NEBRASKA CAPITOL ENVIRONS COMMISSION

NEBRASKA CAPITOL ENVIRONS COMMISSION STAFF REPORT

APPLICATION NUMBER	Urban Design Record #22093
APPLICATION TYPE	Certificate of Appropriateness
ADDRESS/LOCATION	220 Centennial Mall S
HEARING DATE	July 28, 2023
ADDITIONAL MEETINGS	February 25, 2022 (original hearing date)
APPLICANT	Drew Sova, 402-408-0005, dsova@whitelotusgroup.com
STAFF CONTACT	Collin Christopher, 402-441-6370, cchristopher@lincoln.ne.gov

NEBRASKA CAPITOL ENVIRONS COMMISSION STAFF REPORT

ATTACHMENT B – Renderings

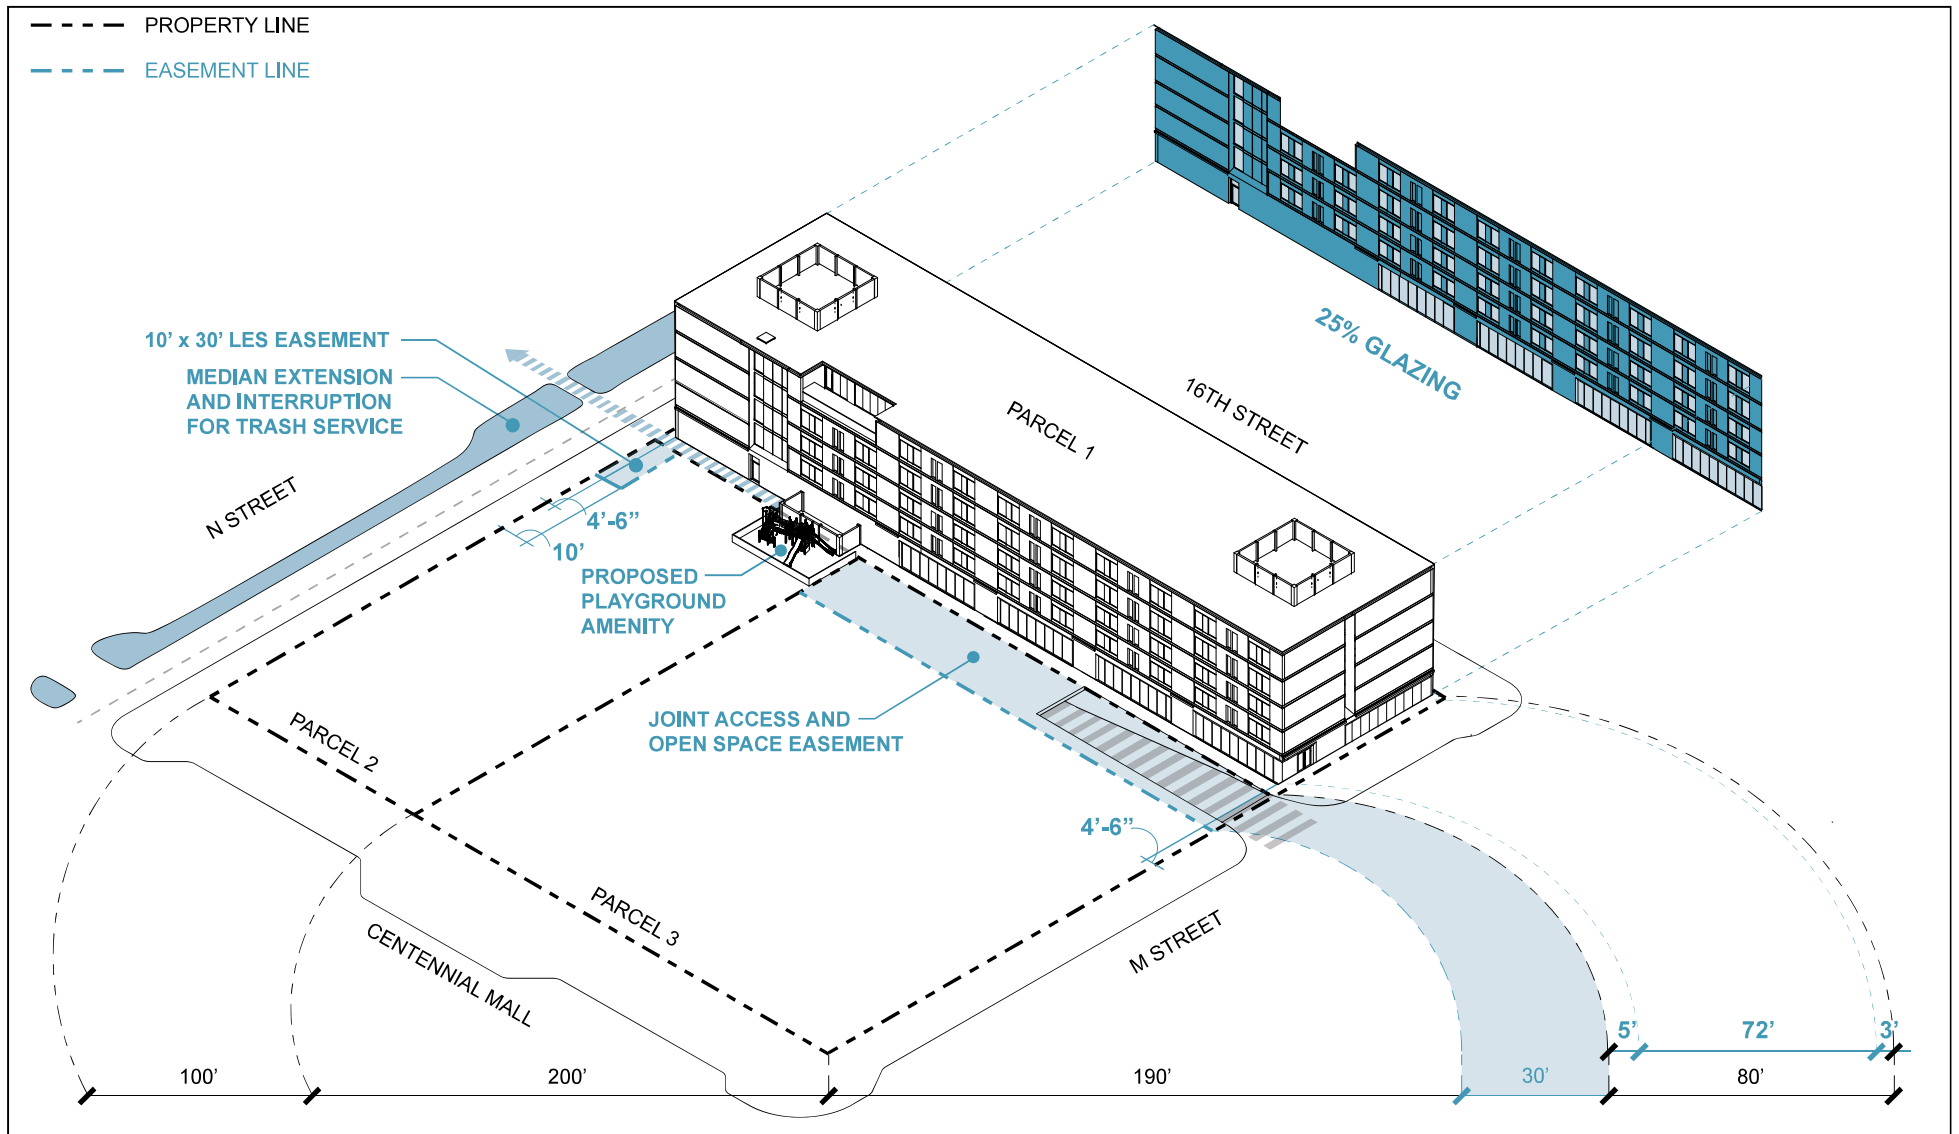
- **Façade modifications** – The most noticeable façade change relates to the color palette for the façade. The original plans submitted in 2022 showed a light brick product on the lower level with a darker brick on the upper levels. The updated plans offer a reverse approach – light brick below and dark brick above. Beyond that, the widow placement/transparency appears to have been modified in subtle ways that do not appear to have a material effect on the quality of the facades.

The images on the left represent the design approved in February 2022 and the images on the right show the modified design submitted for an updated certificate.

In comparing the plans approved in February 2022 with those submitted as part of this review, staff believes that the façade-related changes do not result in a diminished project. The changes in the masonry choices are a matter of preference and not of quality or durability. Likewise, the modifications to the

M AND N STREET SETBACK CONDITIONS

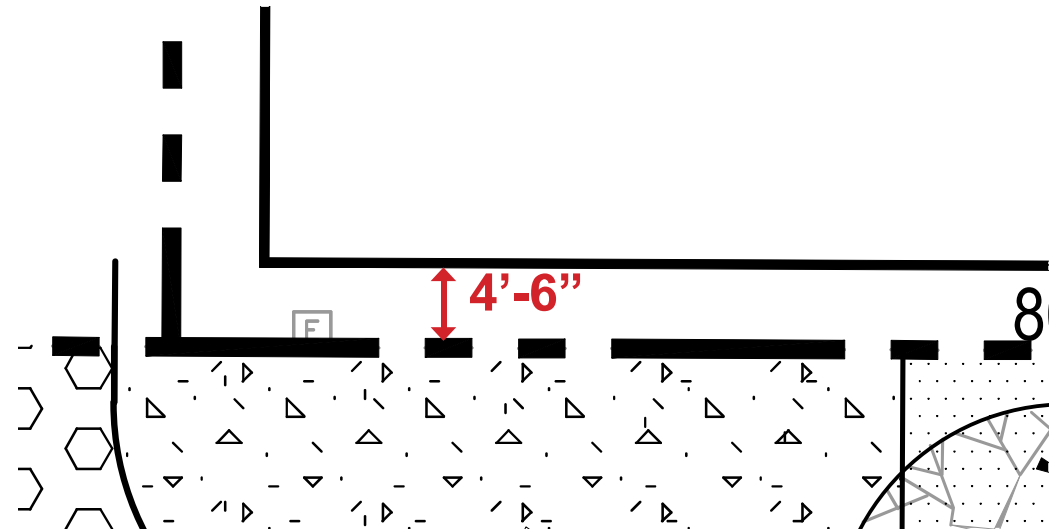
- **Building setback modifications** – The 2022 plans were processed and reviewed by staff with the assumption that the building was being built to the M, N and 16th Street property lines, as is standard for new development in downtown Lincoln. This was not a topic of discussion at that February 2022 meeting, per the approved minutes. The modified proposal shows a 3’ setback from S 16th Street, and a 4.5’ setback on the M and N Street sides.

In discussions with the applicant regarding the building setbacks, staff has conveyed a desire to have the project be built to the property lines, per the Downtown Design Standards. However, the applicant has made a case for why the small setbacks are necessary. Per the application material submitted, those reasons are as follows:

1. Affordable housing unit layout design is driving building footprint size. There is not sufficient additional space in the north/south parcel lot dimension for an additional housing unit to be integrated in the plan layout.
2. Design space is needed at the north along N street to locate intake air for underground parking ventilation, and also at the south along M street for exhaust air. This chase and its supporting structure must be included on the project property extents.
3. Indicated offsets from the front property lines allow that building footings will be able to be designed and constructed within project property boundaries, and will avoid any potential conflicts with City of Lincoln public easements for utilities.

Staff's perspective regarding the setbacks is a little more nuanced. The Downtown Design Standards are clear in their expectations and allowing a deviation of this nature impacts not only future urban design decisions on this block but also on the blocks that surround it. At the same time, one might argue that a setback of 3' or 4'-6" is not a distance that most will notice, and that the value add of the affordable housing and other uses to be contained within this block are much more important and relevant to the future of downtown and the Capitol Environs District. Ultimately, staff understands the complex nature of a project like this and seeks NCEC's guidance on how to proceed.

1 Site Planting & Irrigation Plan
SCALE: 1/16" = 1' - 0"

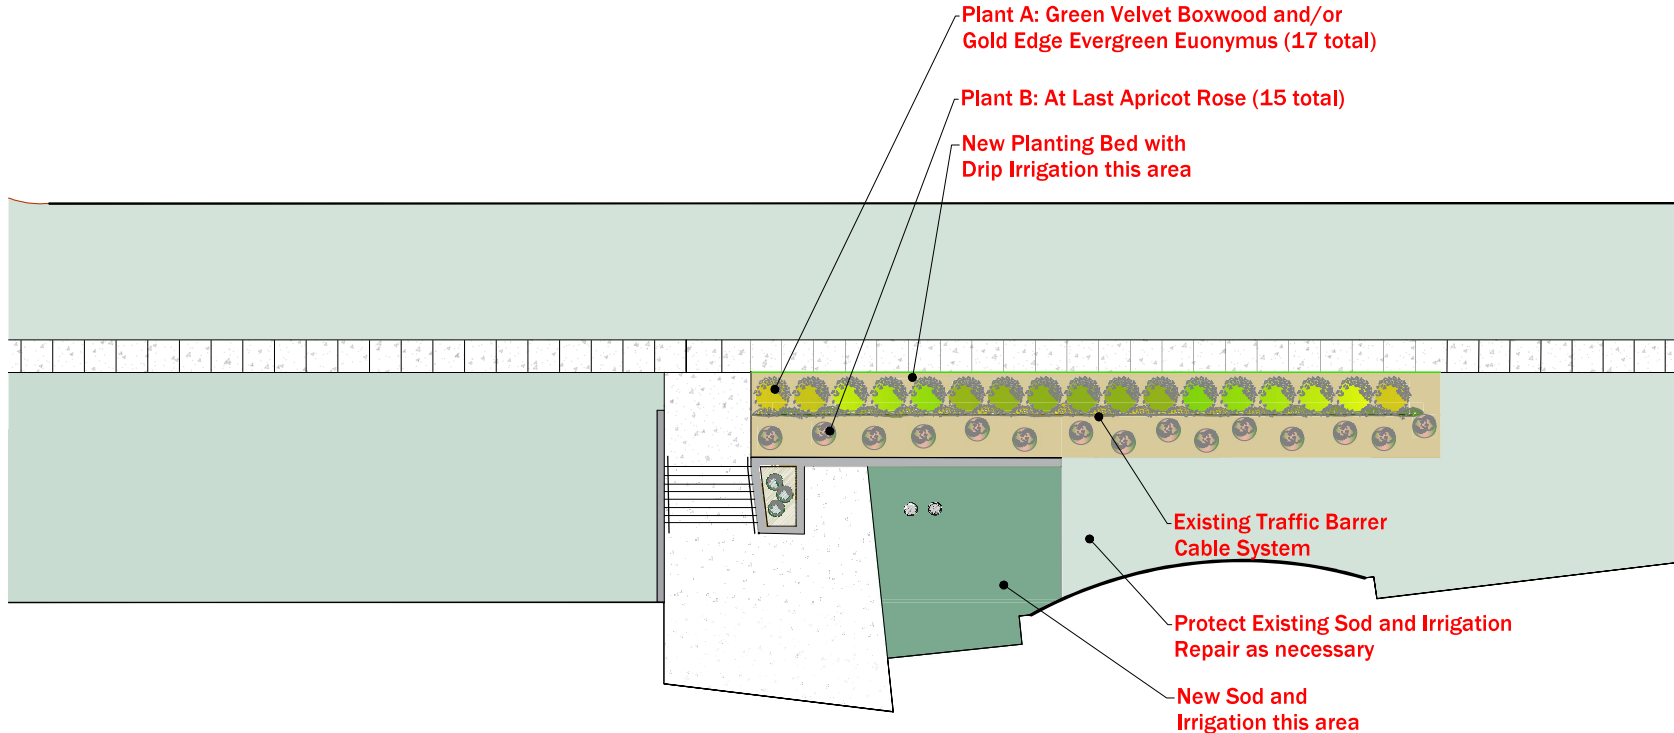
While the proposed landscape plan appears to meet the intent of the design standards, the Commission should weigh in on any specific concerns related to plant species, spacing, or maintenance of the proposed landscape improvements.

Recommended finding: The proposed landscape plan complies with the Capitol Environs Design Standards.

Recommended action: Approval of an updated Certificate of Appropriateness for the proposed work at 1821/1843 K Street.
